**FRONTEER WIND FARM, EASTERN CAPE PROVINCE
(DFFE Reference No.: 14/12/16/3/3/1/2315)**

COMMENTS AND RESPONSES REPORT

Figure 7: Choje West - Steep slopes, prominent hills, ridges and skylines.

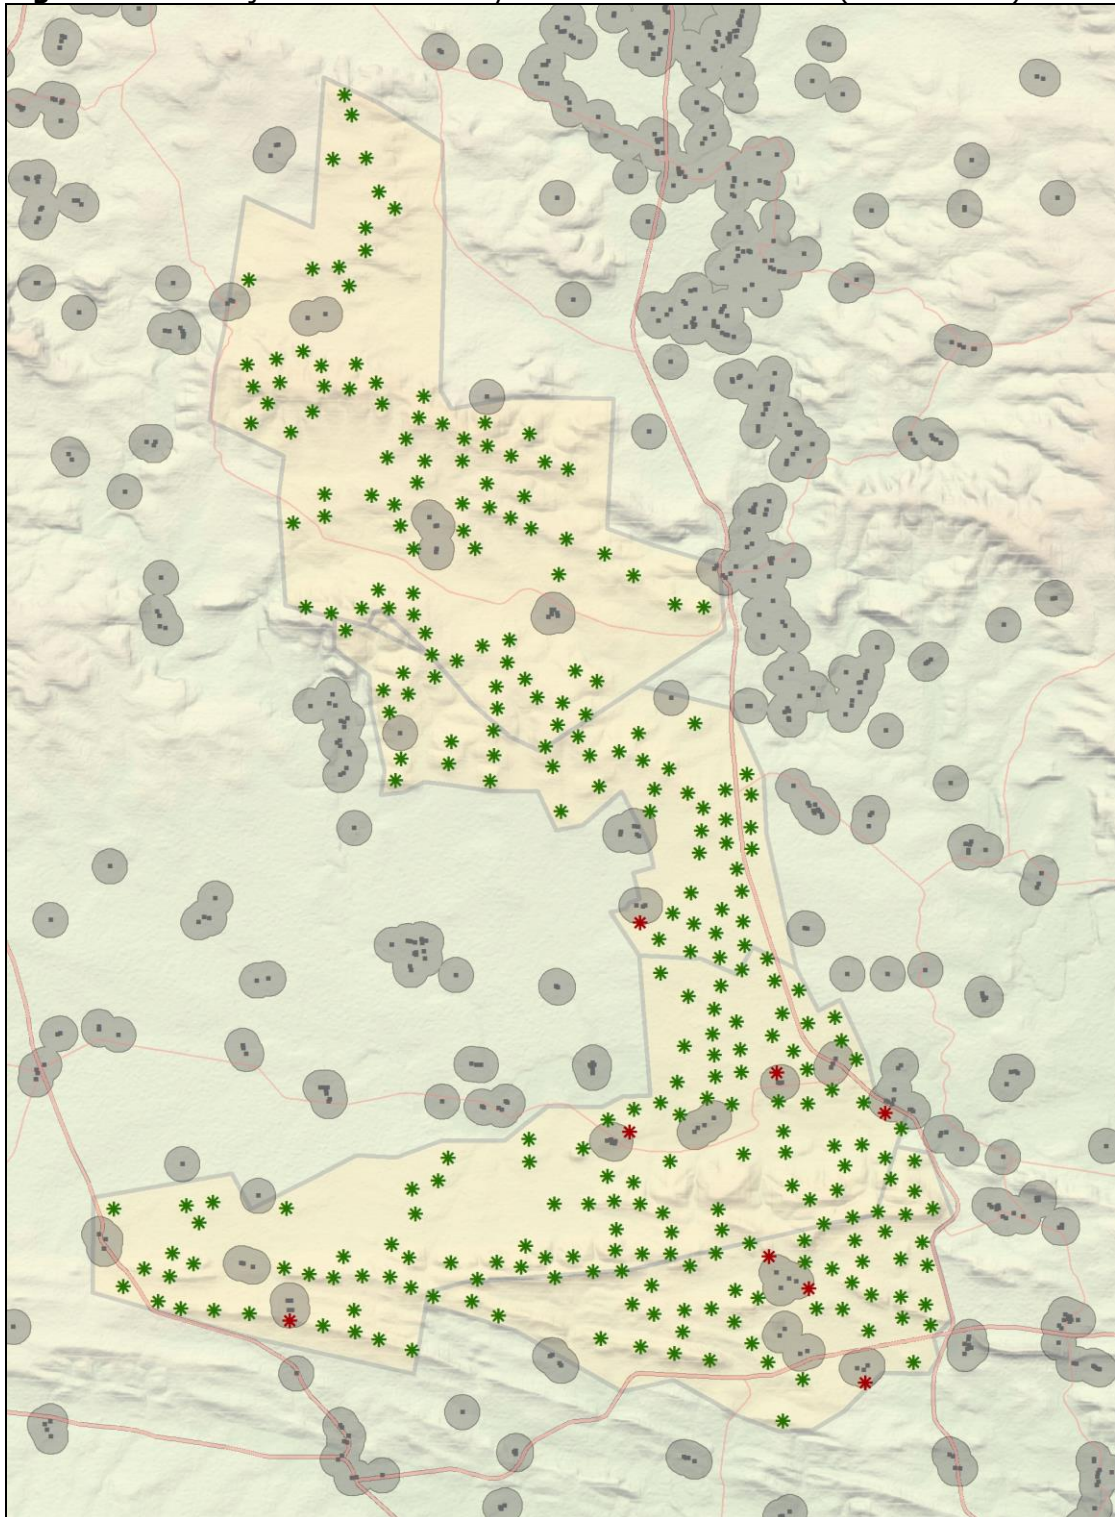
107 turbines are located on exposed topographical units.
